CONTRACT CHANGE ORDER NO. 25
SHEET ___ OF ___

SAN FRANCISCO OAKLAND BAY BRIDGE
EAST SPAN SEISMIC SAFETY PROJECT

SEISMIC JOINT (HINGE A)

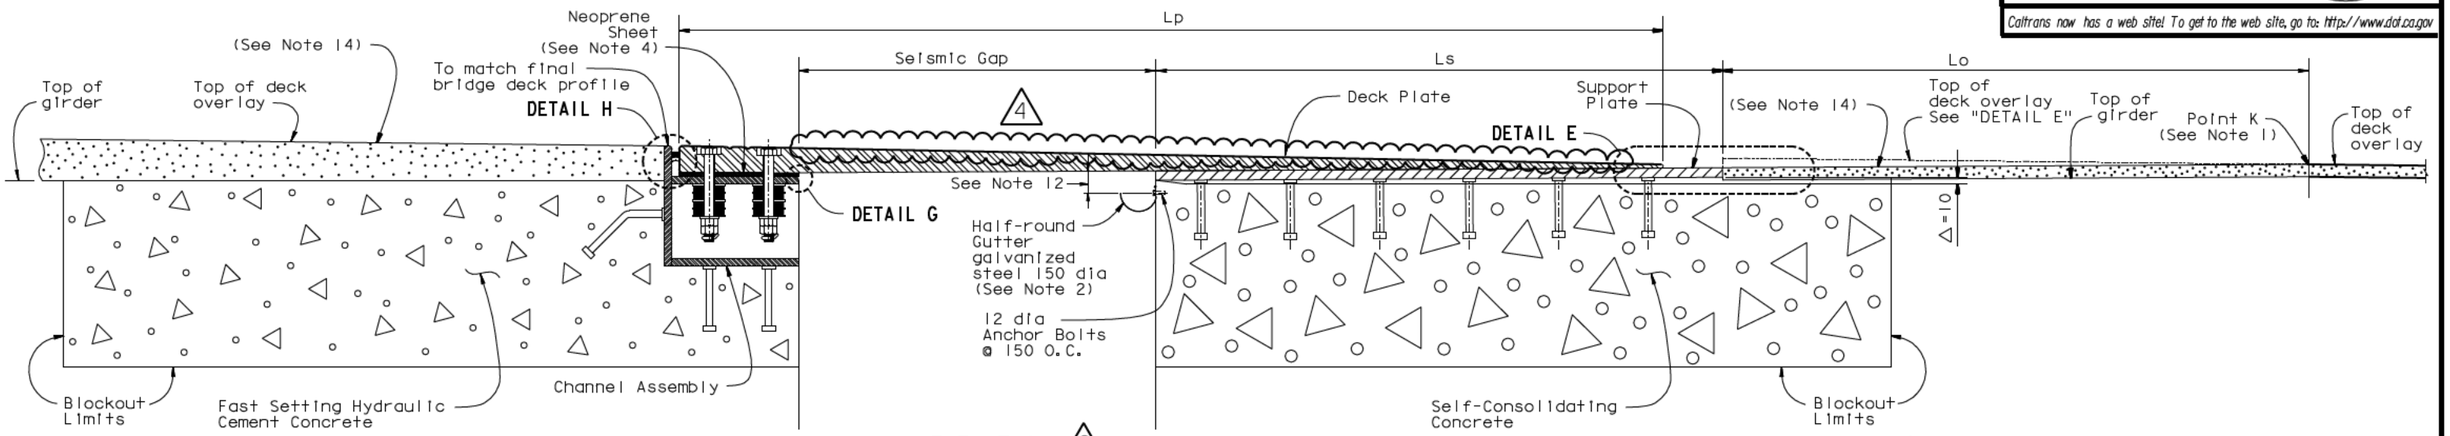
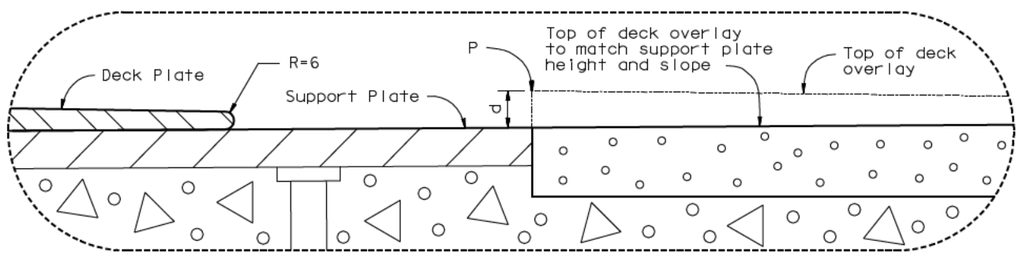
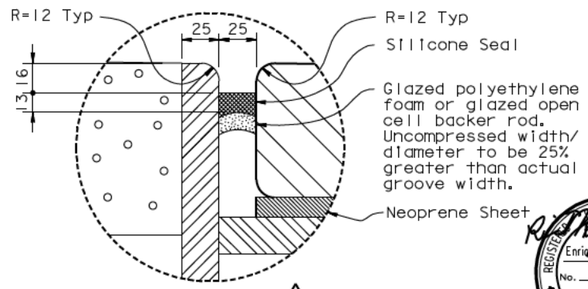
FOR REVISION 4 ONLY

MARK	DATE	DESCRIPTIONS	BY	CH'D	CCO #
4	10/30/09	Seismic Joint Modifications Hinge A	RM	AA	25
3	7/17/08	Seismic Joint Modifications Hinge A	TD	AK	25
2	12/18/07	Seismic Joint Modifications Hinge A	TD	AK	25
1	9/15/06	Joint Improvements	TD	AK	25

JOINT INFORMATION 2			
LOCATION		HINGE AE	HINGE AW
SKEW (°)		0	0
DECK PLATE	Thickness td (mm)	90	90
	Length Lp (mm)	3300	3300
SUPPORT PLATE	Thickness ts (mm)	32	32
	Length Ls (mm)	1900	1900
SEISMIC GAP @ 20°	(mm)	1200	1200
3 TRANSITION DEPTH	d (mm)	25	25
P (See DETAIL E)	STA	62+04.188	62+14.885
	ELEV	48.635	49.444
3 TRANSITION LENGTH	Lo (mm)	±1300	±1300
